802.3dj D2.0

Comment Resolution

Logic Track

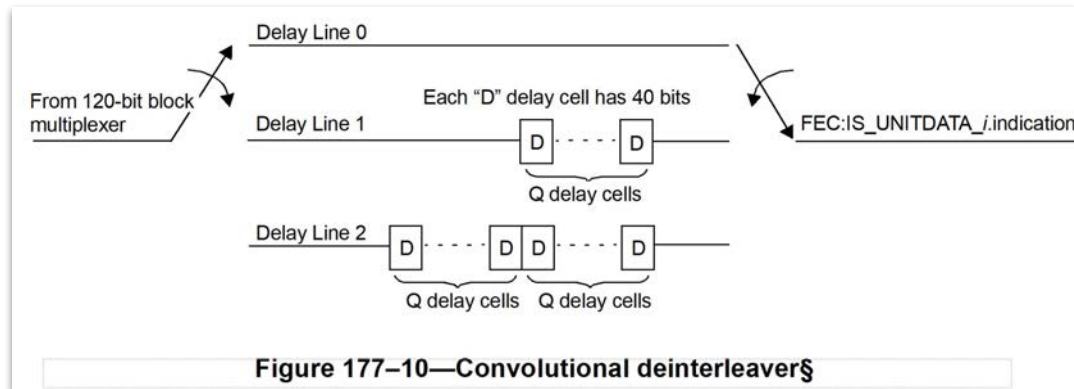
Add a figure that describes the convolutional deinterleaver (refer to 184.5.8)

The proposed response is “PROPOSED ACCEPT IN PRINCIPLE. Add figure to illustrate the convolutional deinterleaving process”. There isn’t enough guidance for the figure; Preferably, the commenter (or the editor, if he volunteers) should implement and present the suggested figure, otherwise the CRG does not know what it is supposed to accept. Until then, the proposed response should be REJECT: the SR does not include sufficient detail to implement.

Add figure to illustrate the convolutional deinterleaving process.

Insert the following figure in “177.5.8 Convolutional deinterleaver”

Figure 177A-1—Test points for test vectors

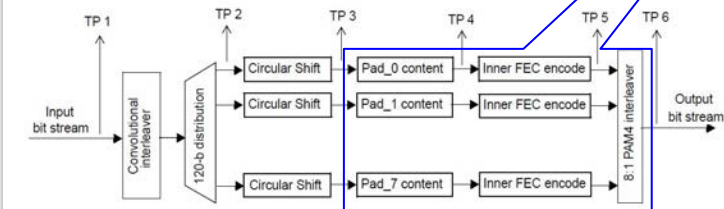
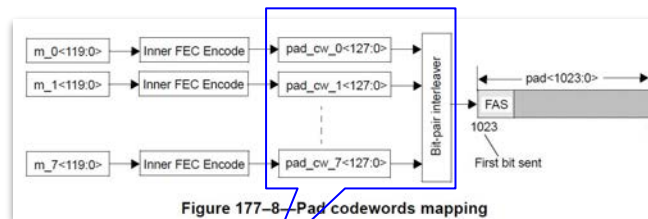
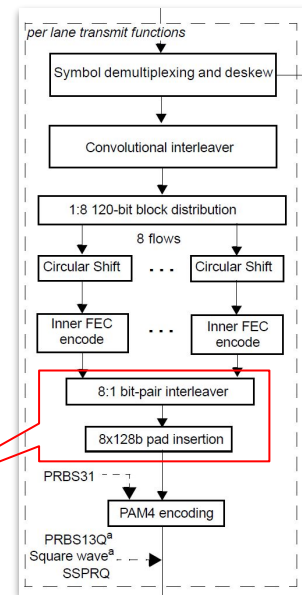
Figure 177A-1 shows the pad insertion in a different position than Figure 177-2

In Figure 177-8 and 177A-1, it seems like “pad insertion” is **before** the “8:1 bit-pair interleaver”.

In Figure 177-2, “pad insertion” is **after** “8:1 bit-pair interleaver”.

Either move the pad insertion in Figure 177-2 to be before the Inner FEC encoder, or move it in Figure 177A-1 to be after the 8:1 PAM4 interleaver block

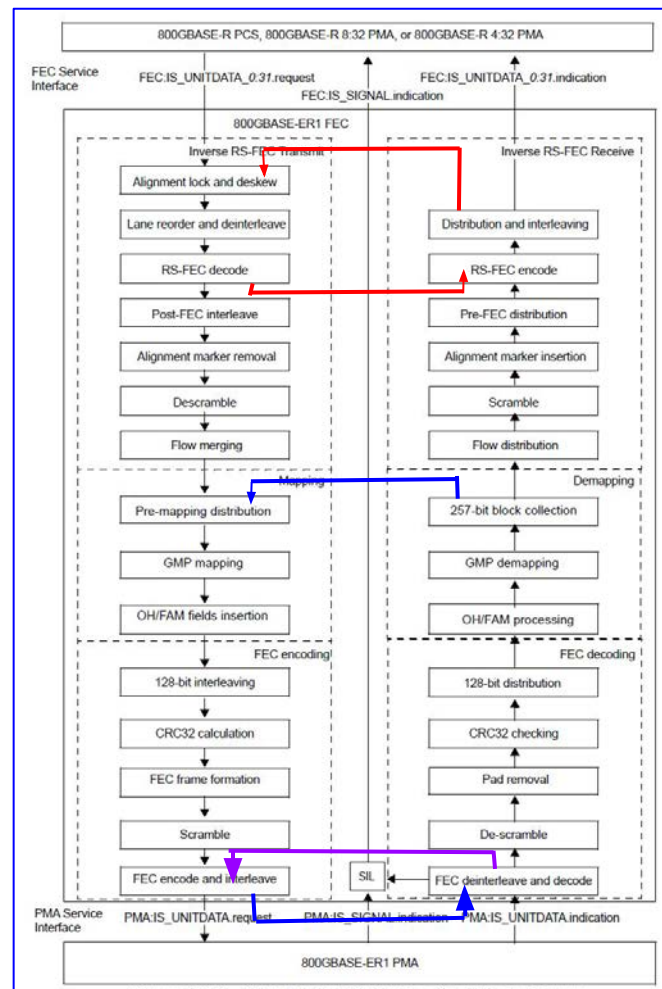
Add a subclause for loopbacks that is aligned to what is in OIF 800ZR

Add new subclause 186.2.5 for FEC loopbacks and 186.3.5 for PMA loopbacks. Update 186.7 (management variables and 186.8 (PICS) accordingly.

Insert new subclause 186.2.5 to describe these loopbacks, add new management variables to control these loopbacks (one to indicate whether each loopback is supported, one to indicate whether it is activated), and update PICS (more detail on next slide)
